Subject: FW: For Pier Tenant Input: North Parking Structure Circulation Mods

Gene Kim, City Traffic Engineer, will be taking an item to the Public Works Commission meeting on September 28th regarding considerations for circulation modifications for the north parking structure. The recommendations will be made based on, what Gene understands, requests made from the pier tenants. There are two modifications shown in the attachment, with the associated advantages/disadvantages for either option.

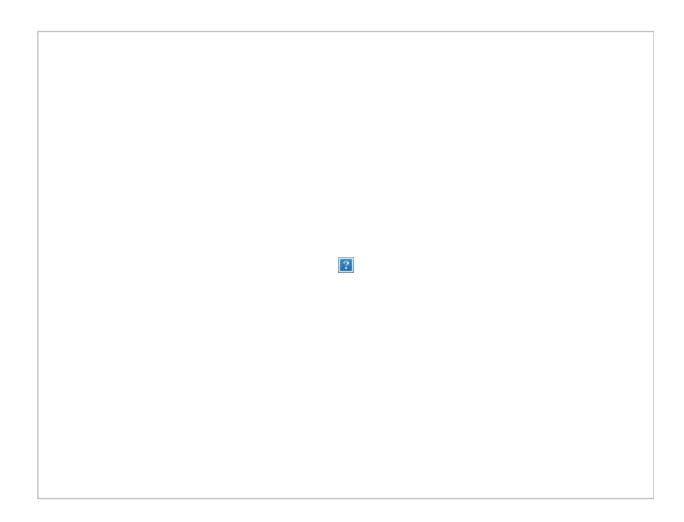
I feel like the main reason of this change is not mentioned in "advantages" or in the email which is: currently people do not notice the underground parking and they cycle through the upstairs parking when it is full, after making one loop they proceed to exit as that is what is in front of them. Meanwhile there is still much more parking available downstairs which un unknown to them. By reversing the direction upstairs it allows for people who have cycled through the upstairs area to now be facing the downstairs parking which will have better visibility and better signage advising them to drive straight ahead for more parking. This will help the city generate more money in parking and help the business get more customers as there is no guarantee we will see a customer once they leave the parking lot, they may very well go somewhere else that is "less crowded".

After reviewing your diagram here are a few suggestions.

- 1. Add a stop sign floor marking at the end of the upstairs parking, this allows people to stop and better see signs. Under that stop sign put the "park straight arrow / right arrow exit park sign" below the stop sign. There is also traffic exiting from downstairs turning left which is opposing traffic so stop sign would be saver.

- 2. I didn't mark this but so the same thing with the exit park sign at the stop sign, put the arrow signs under the stop sign rather that across the way as they are in both stop sign situations. This will allow for better visibility of arrows advising additional parking.

- 3. At the top of the ramp upon exiting downstairs make the arrow to the left rather than straight.
- 4. The 2 or 3 parking spots between the entrance and the power building where the stop sign is may become somewhat obsolete and hard to access with stop sign in front of it. Turning those into motorcycle parking may be more suitable as they can maneuver easily and you can fit more spots into that small area.

Besides that it looks great, if you don't like stop sign addition, maybe put up a yield sign at least as there will be opposing traffic turning left from exiting downstairs.
